ASEP for L5 vehicles with CVT/AT

Issue with the proposed Supplement the 08 series of amendments to UN R9,
as in *GRB-68-22 (= WP29-2019-006)*

Background of IMMA proposal for revised exemption window, as in GRB-69-14

With originally proposal exemption window (as in GRB-68-22)

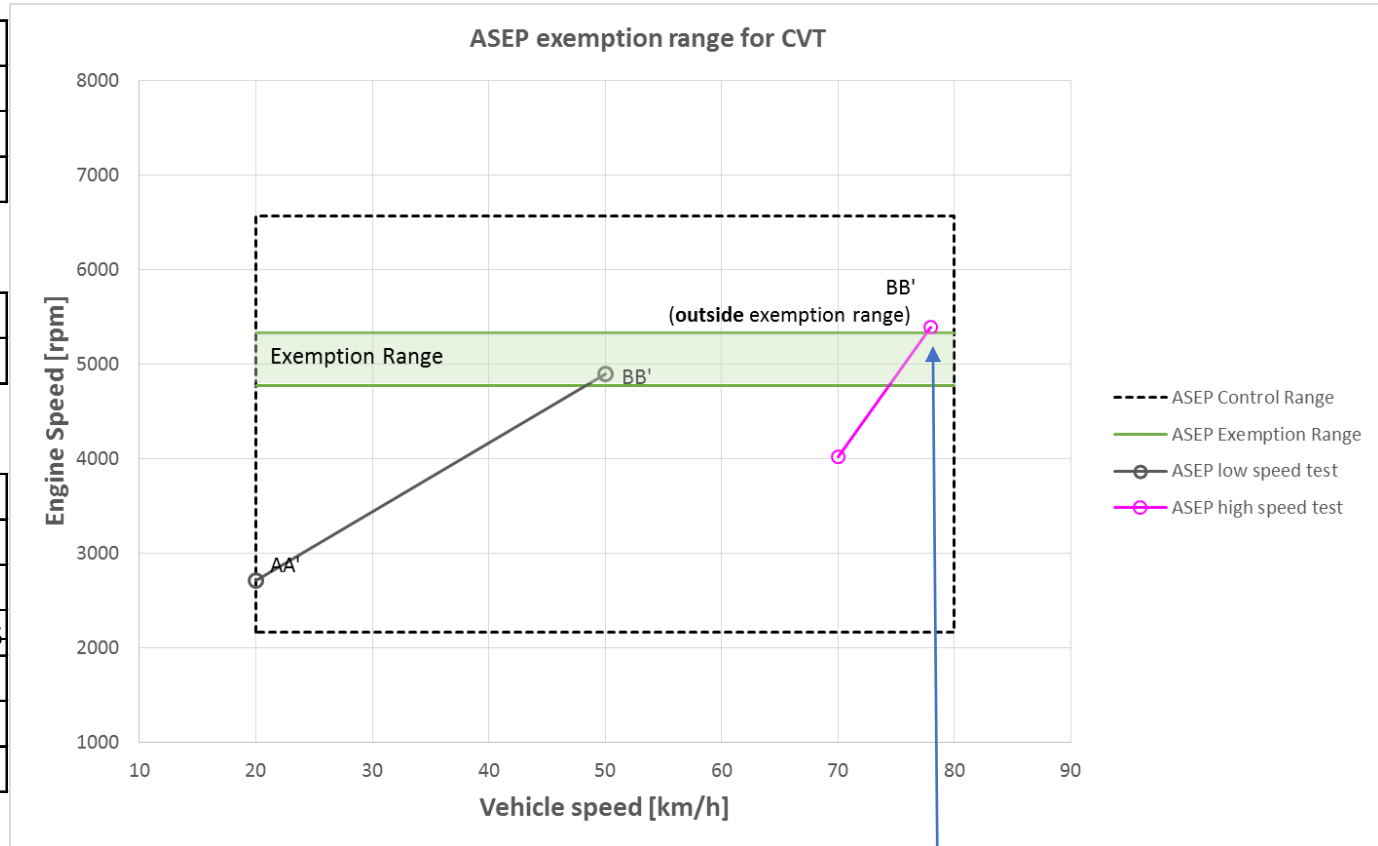
BB' outside exemption range:
**Vehicle not exempted from
ASEP testing**

With IMMA proposal for revised exemption window (as in GRB-69-14)

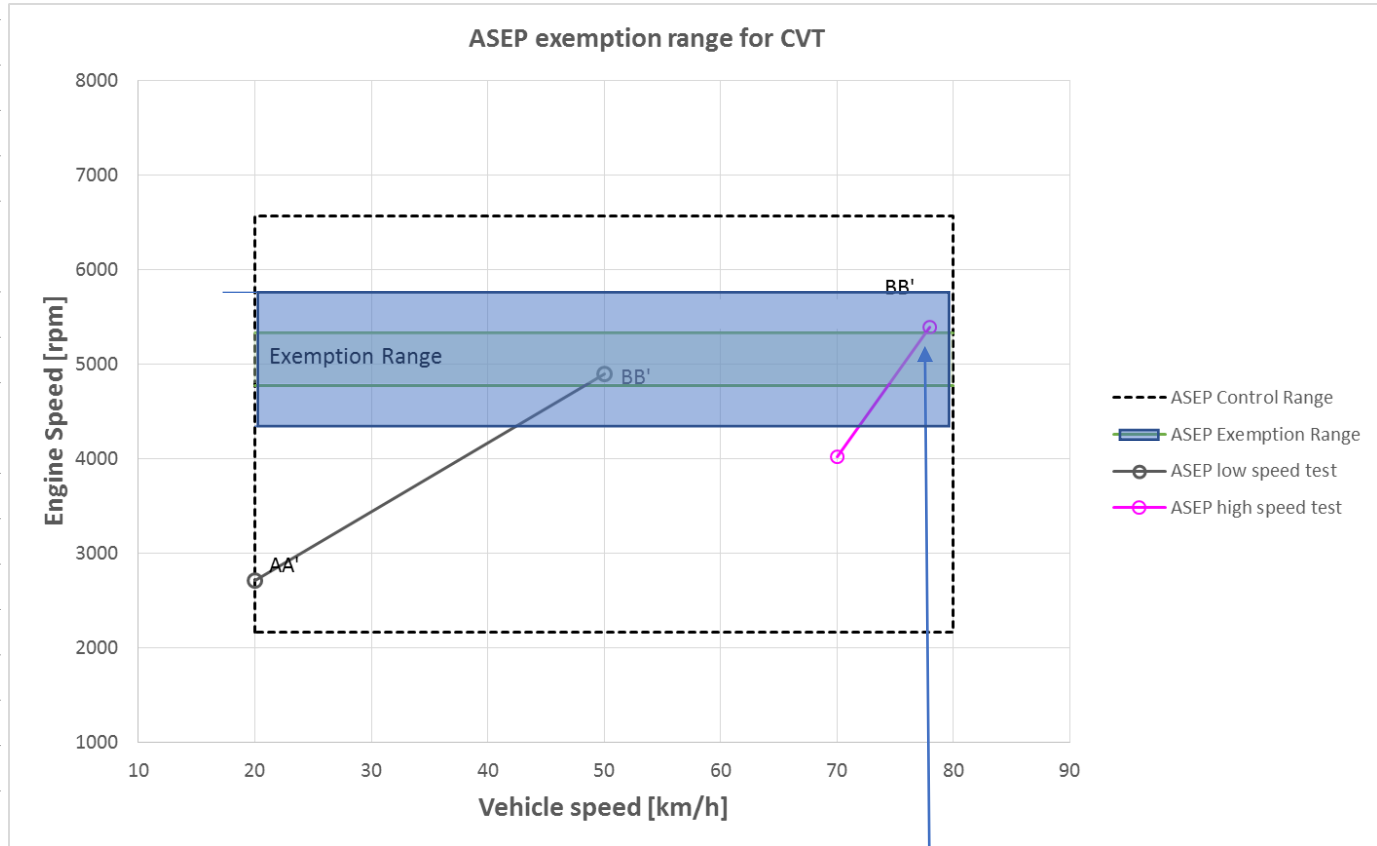
BB' inside exemption range:
Vehicle exempted from ASEP testing

UN R9, *Annex 6, paragraph 1.2.*, amend to read

Vehicles with variable gear ratios or automatic transmission with non-lockable gear ratios are exempted from the requirements of this Annex, if the vehicle manufacturer provides technical documents to the Type Approval Authority showing, that the vehicle's engine speed at BB' does neither exceed **$1.15 * n_{BB'}_{ref}$** (~~$n_{BB'} + 0.05 * (n_{rated} - n_{idle})$~~) nor fall below **$0.85 * n_{BB'}_{ref}$** (~~$n_{BB'} - 0.05 * (n_{rated} - n_{idle})$~~) for any test condition inside the ASEP control range defined in paragraph 2.5. below, where **$n_{BB'}_{ref}$** is **calculated in accordance to paragraph 3.3.1. of this Annex.** (~~$n_{BB'}$ is the average engine speed at BB' from the two valid acceleration tests according to paragraphs 2. and 3. of Annex 3.~~)
